**COA (SP) 2016-029
December 15, 2016**

**STAFF REPORT
SPECIAL CERTIFICATE OF APPROPRIATENESS
FOR THE PROPERTY AT
2907 COLUMBUS BOULEVARD
A LOCAL HISTORIC LANDMARK**

Proposal: The application requests design approval for additions and alterations to the residence and sitework.

Figure 1: Outline of Original Structures at 2907 Columbus Boulevard

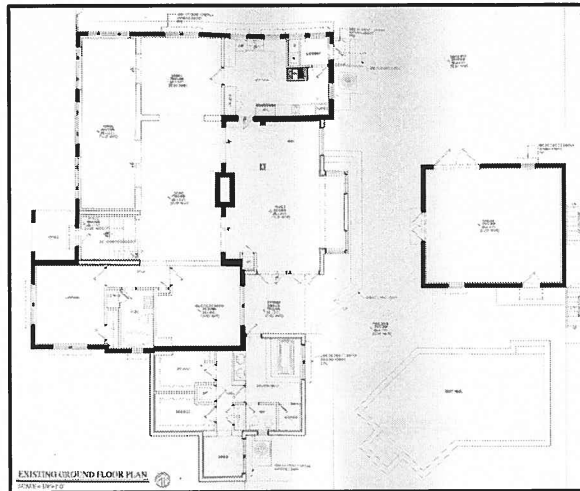
The additions, with the exception of the proposed breakfast area, either take the place of later additions or are connected to later addition. (Figure 1)

Figure 2: Fishbaugh Photograph of 2907 Columbus Boulevard, August 6, 1924

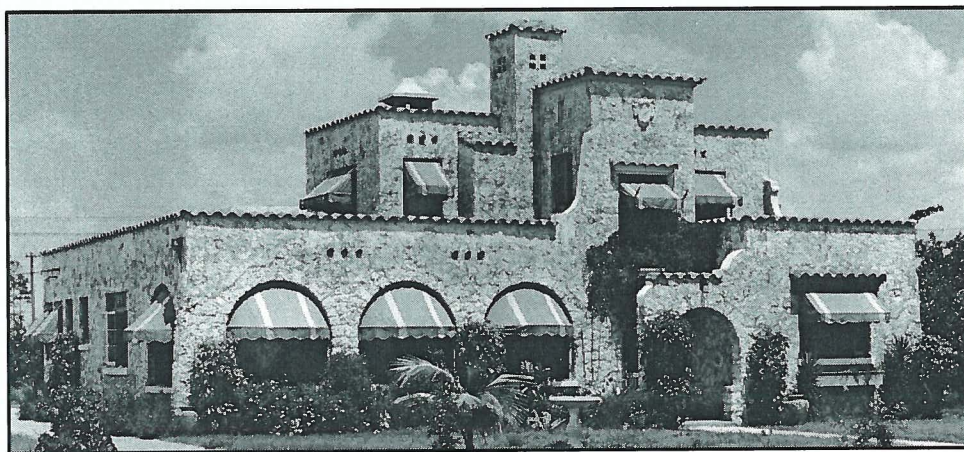
- The elevations and renderings also indicate that the barrel tile hoods above the windows and doors are to remain. Only in a very few instances are those features original (Figure 2). The hood feature was replicated at some unknown date and applied on almost single window or door opening on the residence. Staff would like for the owner to consider removing the later applications and restoring the original look of the historic structure.
